Responses to reviewers:

Reviewer 1:

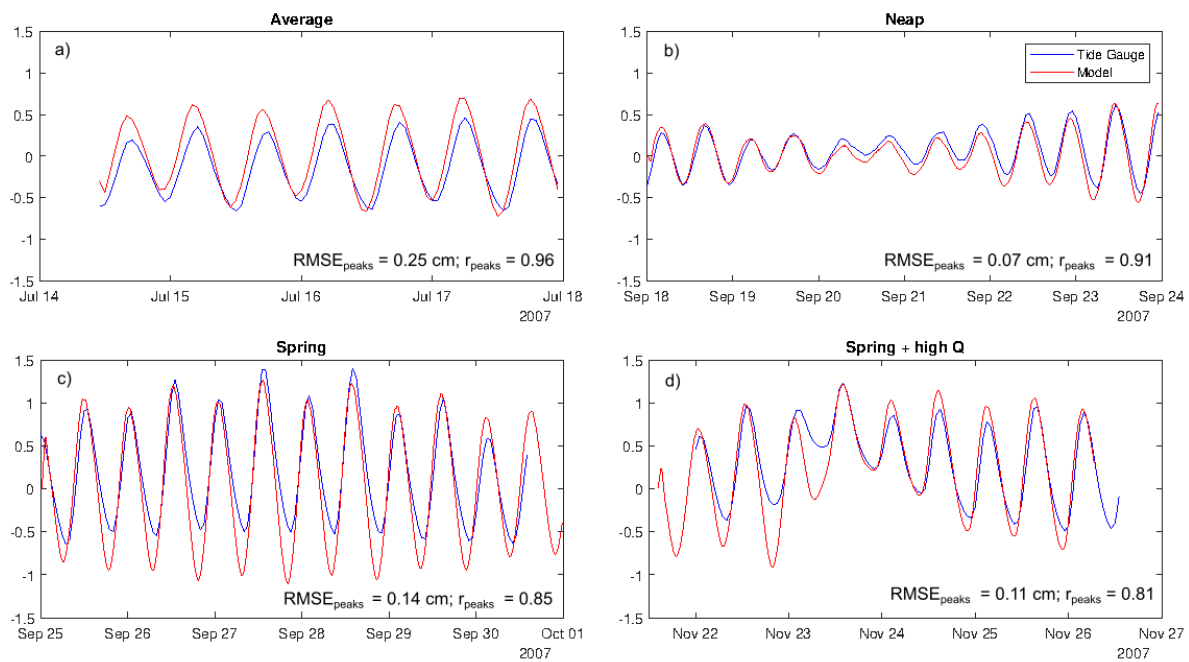
The performance of hydrodynamic model is arguable as some deficiencies in model accuracy in terms of water elevations exist (velocity magnitudes are not validated). The validation results show some significant discrepancies between the model and observations, this is further confirmed by RMSEs, which for tide+Q WL is 0.62. While this number is very high in the flood context, it seems from fig 3 that these discrepancies are primarily generated on low water peaks of spring conditions while high water peaks (which are of relevance in this study) are quite comparable. The separate analyses of RMSE for neap, spring tides and low and high water would be useful in the process of validation.

In Table 3, I would suggest to present statistical analysis separately for spring, neap and average (and perhaps for close to peak values only) to better understand the source of an error.

Thank you for this comment. Following your suggestion and the suggestion of the second reviewer, we have estimated the goodness-of-fit for WL peaks of each individual event used for model validation. The results of the additional statistical analysis are presented in the following table. We moved this table to Appendix C, as we included the additionally calculated goodness-of-fit estimates for the peak values of each individual tidal event in Figure 3.

We hope that this analysis of RMSE for peak values brings more clarity regarding the source of the error and highlights model performance at peak values.

Moreover, we would like to particularly thank the reviewer for this comment as, by recalculating the statistical measures, following the comment below, we detected an error in the previous goodness-of-fit estimates for the “Spring-, neap-, average tide & Spring + high Q” analysis. We included the

corrected values in the table, which leads to large improvements in the model results. We also corrected the RMSE of all peak values, being now 0.15 cm, which we corrected in the manuscript in line 264.

Figure 5. Comparison of flood extents of compound and excluding driver scenarios (left panel, a), b) and c)) and differences in flood depths (right panel). Panel d) shows the flood depths of $S_{TWQ} - S_{TW}$, e) shows $S_{TWQ} - S_{TQ}$ and f) $S_{TWQextr} - S_{TWQ}$.

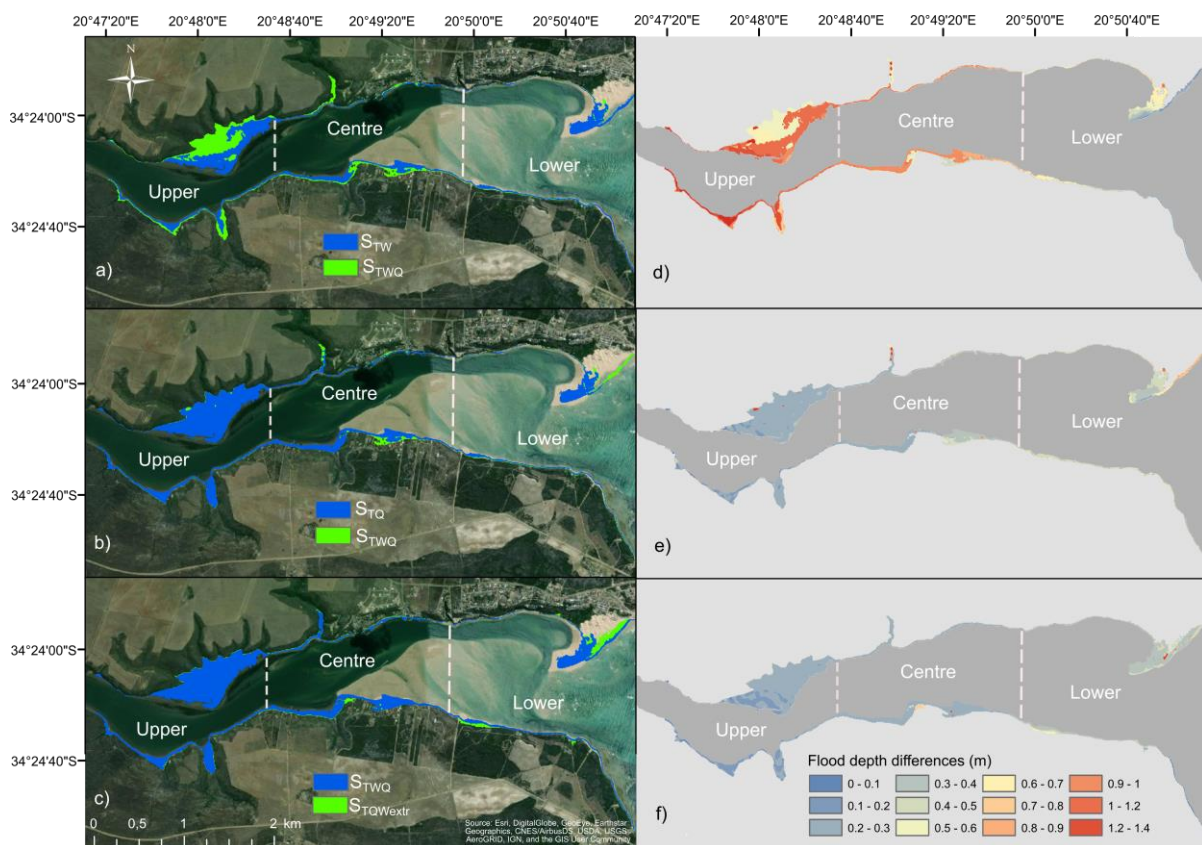
Figure 5, right panel. The colour scale could be refined to better reflect the differences. The interval of 0.3 is substantial in the flood context. The negative values in the range are not used.

We thank you for this advice. We removed the negative values from the legend and decreased the interval to 0.1, as shown in the figure below:

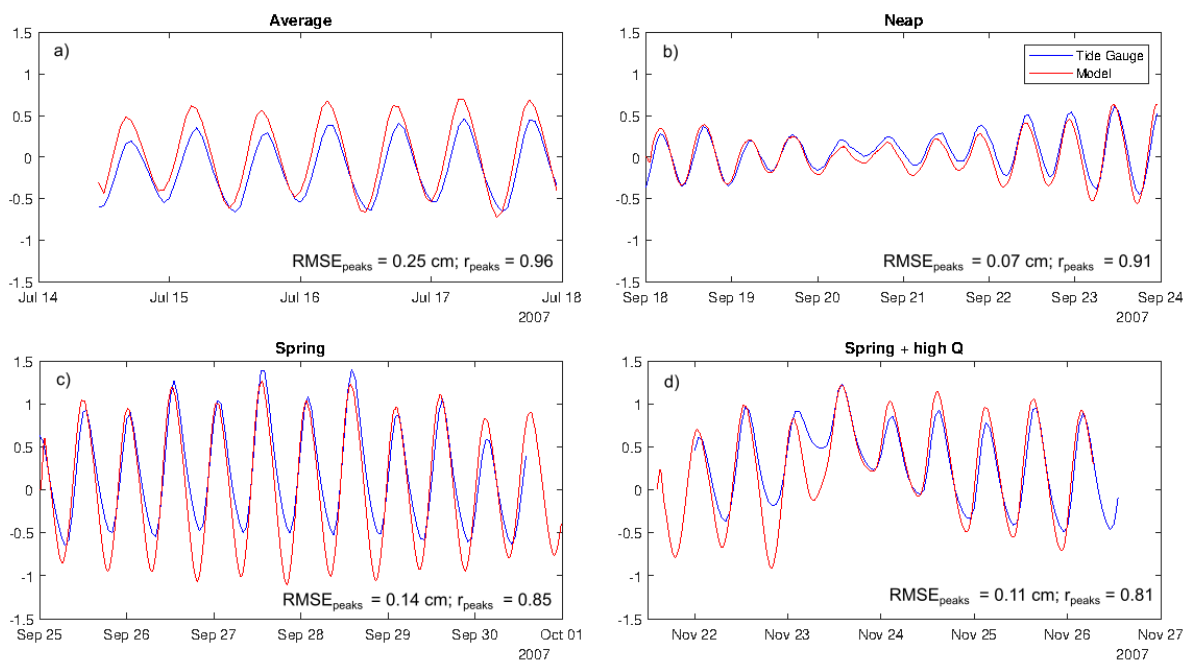
L244: It is not clear how the two columns in Table 3 relate to the four events shown in Figure 3. It would be useful to include all events separately in table 2 or use the same naming or numbering for the events on both. A table of all validation events as mentioned earlier would also help.

Thank you for this suggestion. We adjusted the event names in Figure 3 accordingly to relate to the newly created Table 3. We additionally added goodness-of-fit estimates to the figure and moved Table 3 to Appendix C. Please see our changes in the figure below:

Figure 6. WL maps of the scenarios STQ, STWQ and STQWextr at the same time step (left panel) and time series of all three scenarios, time series of all three scenarios, showing the timing of the onset of the flood, extracted from the point, marked by the blue star.

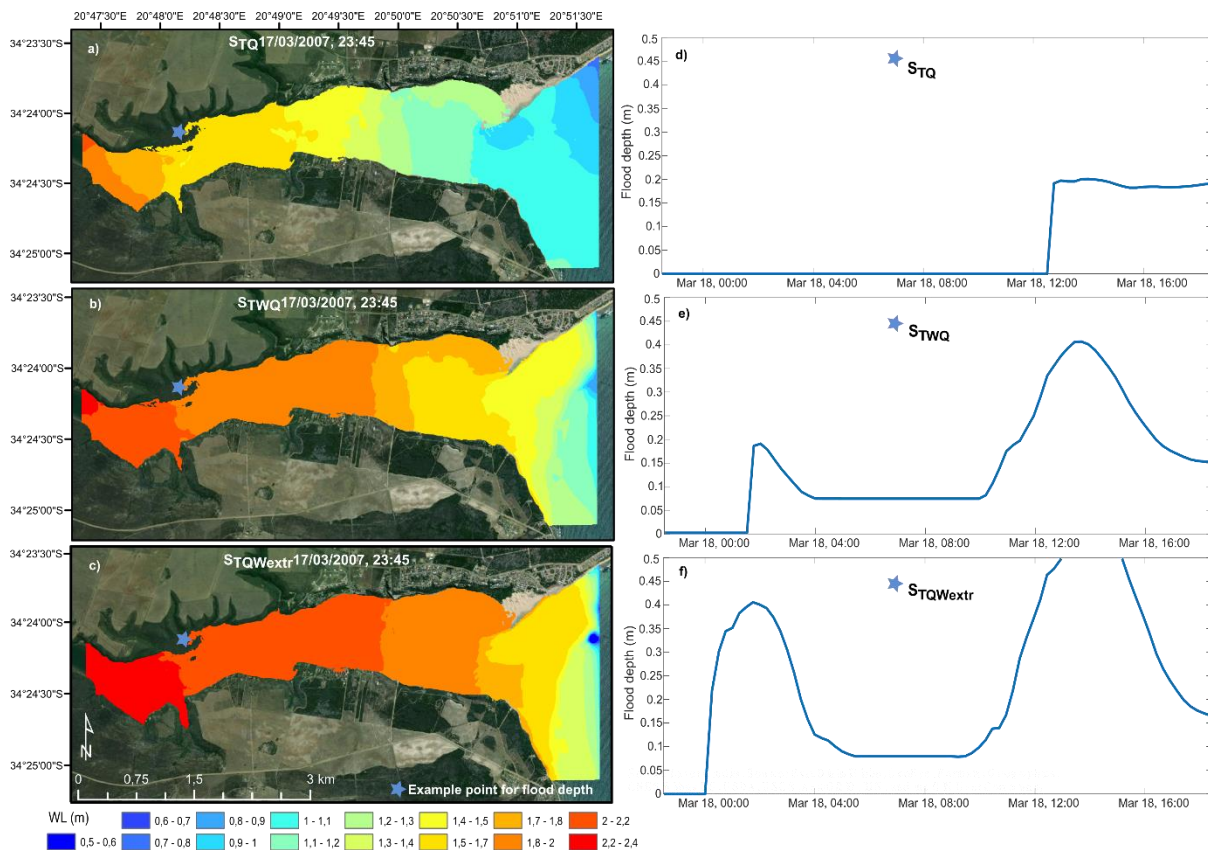
L335: A simple time series plot of WLs at one or more locations would be easier and more appropriate and informative instead of the right panel of Fig. 6.

Thank you for this remark. We agree that a time series of the area highlighted at the right panel in Figure 6 is more intuitive and informative. We therefore replaced all figures of the right panel with time series of all three scenarios, at three different locations. These points are included in each map of the left panel, as shown below. We hope that this modification considerably improves the figure and provides a better insight on the flood timing. We adjusted the text in the manuscript from line 338 accordingly.
